Office Action Summary	Application No. 10/575,989	Applicant(s) JEMELIN ET AL.	
	Examiner RISHI VERMA	Art Unit 3788

Claims 28, 29, 30, 32, 33, 38, 44, 56, 59 are rejected under 35 U.S.C. 103(a) as being obvious over Shumutz et al. (U.S. Patent No. 6261097 B1) in view of Haq et al. (U.S. Patent No.: 6360883 B1) in view of Yen (U.S. Patent No.: 3999434).

FIG. 5

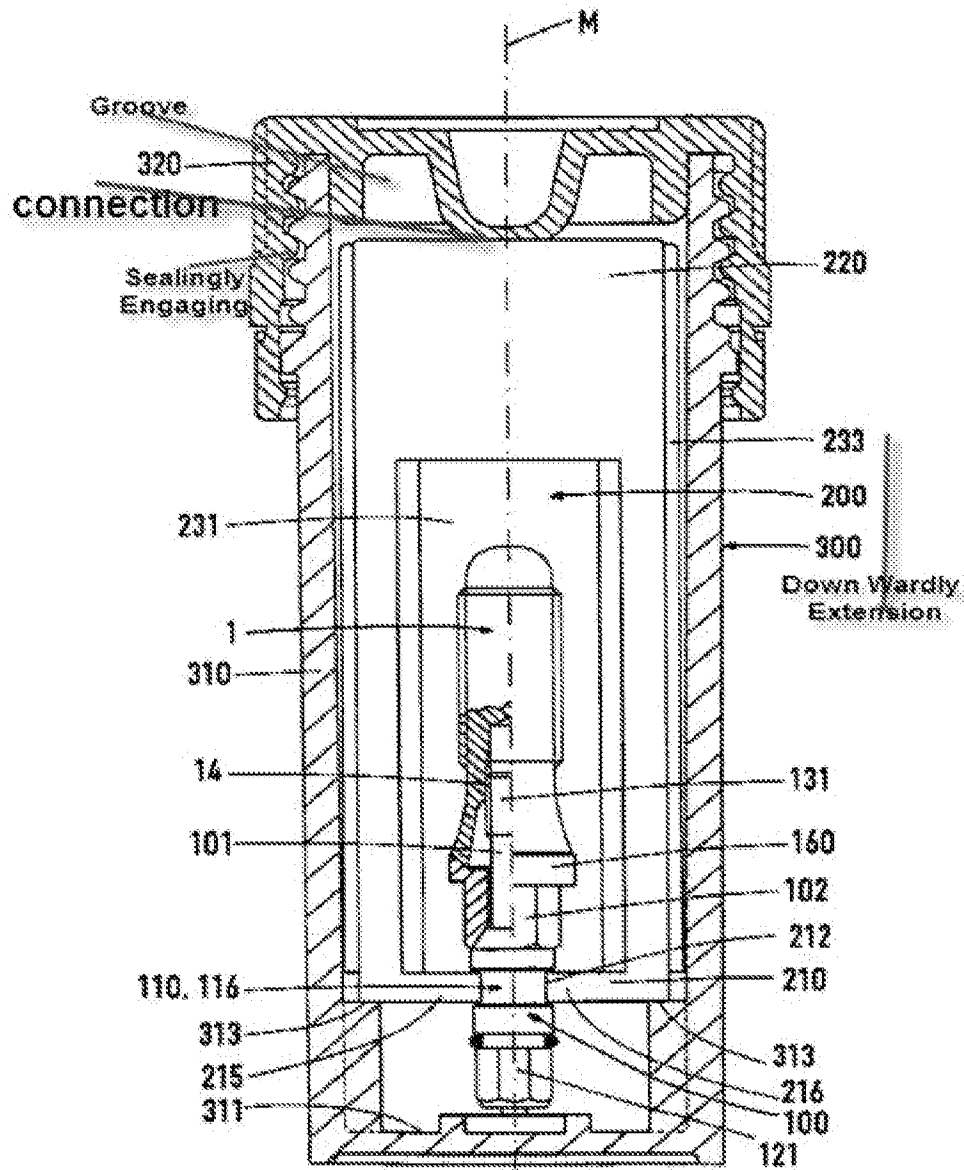
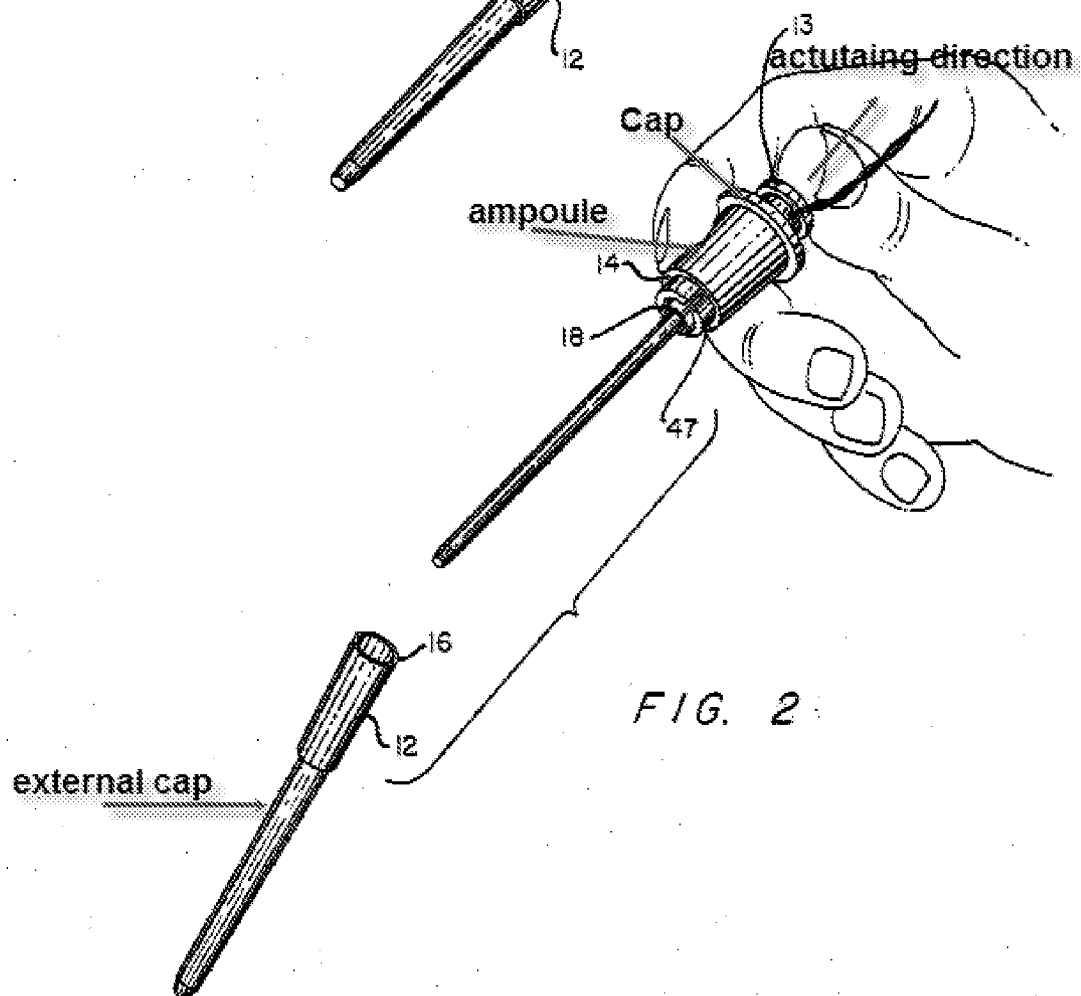
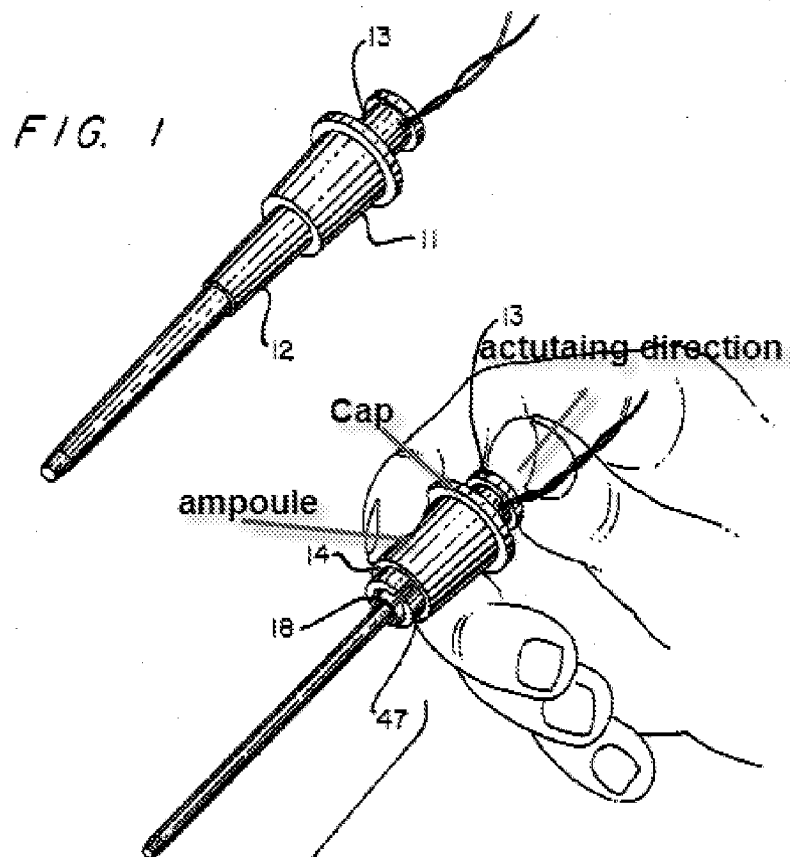
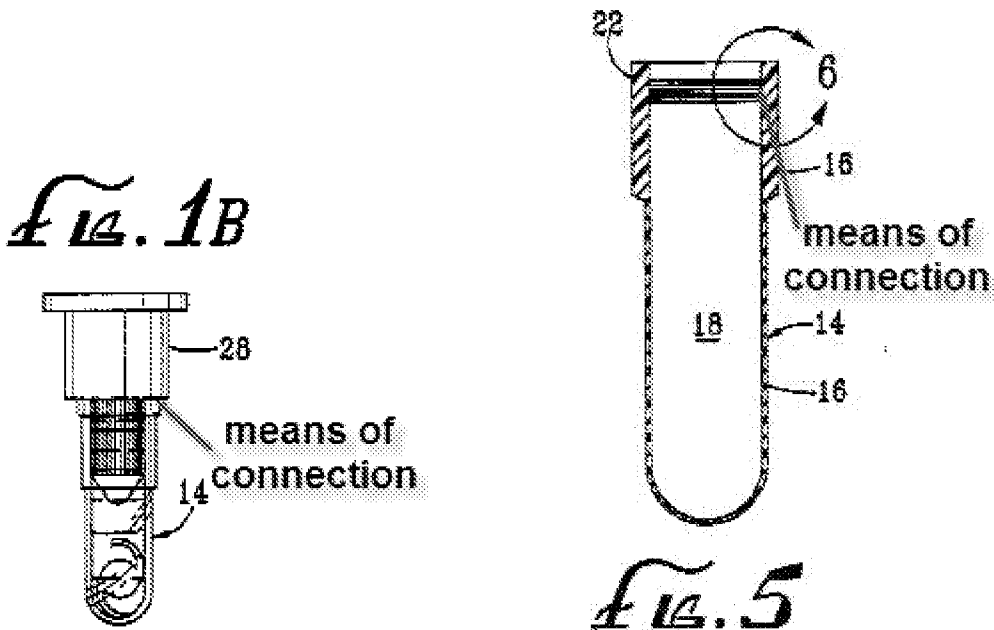
Regarding claim 28, Shumutz et al. teaches a package as illustrated in Fig. 5 capable of preserving a dental implant 1, comprising an external capsule 300; a cap 320 sealingly engaging as labeled above in Fig. 5 the external capsule as illustrated in Fig. 5 and an ampoule 200 capable of holding the dental implant as illustrated in Fig. 5. Shumutz does not teach a means provided to releasably connect to the ampoule such that the means and the ampoule remains connected after removing the cap and the ampoule from the external capsule. Haq teaches a means as labeled above in Fig. 1B and Fig. 5 provided to releasably connect to the ampoule 14 such that the means and the ampoule 14 remains connected after removing the cap and the ampoule from the external capsule 12 as illustrated in Fig. 1B. It would have been obvious to one of the ordinary skills in the art at the time of the invention to modify the means of connection

between the cap 220 and ampoule 200 of Shumutz with means of threads as illustrated in Fig. 5 taught by Haq in order to assist in removing the retained article coincidentally with removal of the closure (Abstract, last sentence).

Shumutz-Haq does not teach an actuating knob. Yen does teach an actuating knob 13 adapted to cause separation of the ampoule from the means when actuated in axial direction of the ampoule in order to use the probe (Yen, column 3, lines 6-10). It would have been obvious to one of the ordinary skills in the art at the time of the invention to modify the top of the cap 320 of Shumutz-Haq by adding an actuating knob 13 as taught by Yen in order to cause separation of the article from the connecting means when actuated in axial direction for use. It has been held that combining prior art elements according to known methods to yield predictable results would have been an obvious extension to prior art teachings, KSR , 550 U.S. at ----, 82 USPQ2d at 1396, MPEP 2114 III A. After the combination of Shumutz et al.-Haq-Yen a actuating knob is provided to releasably connect to the ampoule such that the means and the ampoule remain connected after removing the cap and the ampoule from the external capsule as labeled above in Fig. 2 (Yen).

Regarding claim 32, Shumutz- Haq- Yen teaches the invention as claimed as applied to claim 28, and Shumutz- Haq- Yen further teaches the cap 320 is threadingly engaged as illustrated in Fig. 8A with the external capsule 310 and includes a downward extension which as labeled above in Fig. 5, in an assembled state of the package protrudes between the external capsule and the ampoule to snap engages into a groove of the ampoule as illustrated in Fig. 5.

Regarding claim 33, Shumutz-Haq- Yen teaches the claimed invention as applied to claim 28; Shumutz-Haq-Yen further teaches circular groove as labeled above in Fig. 5. Shumutz- Haq-Yen does not teach a top portion of the cap made out of a elastic

Shumutz-Haq-Yen teaches a connection between ampoule and cap/capsule as labeled above in Fig. 5.
